**URGENT - Medical Device Recall  
IntelliVue MX40**

**Increased Battery Power Consumption and Absence of Low Battery Alerts**

### Device Info Screen

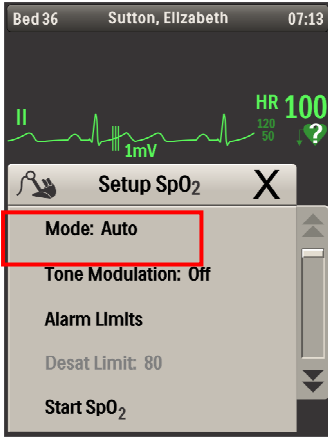
Revision B software

Confirm Revision B software
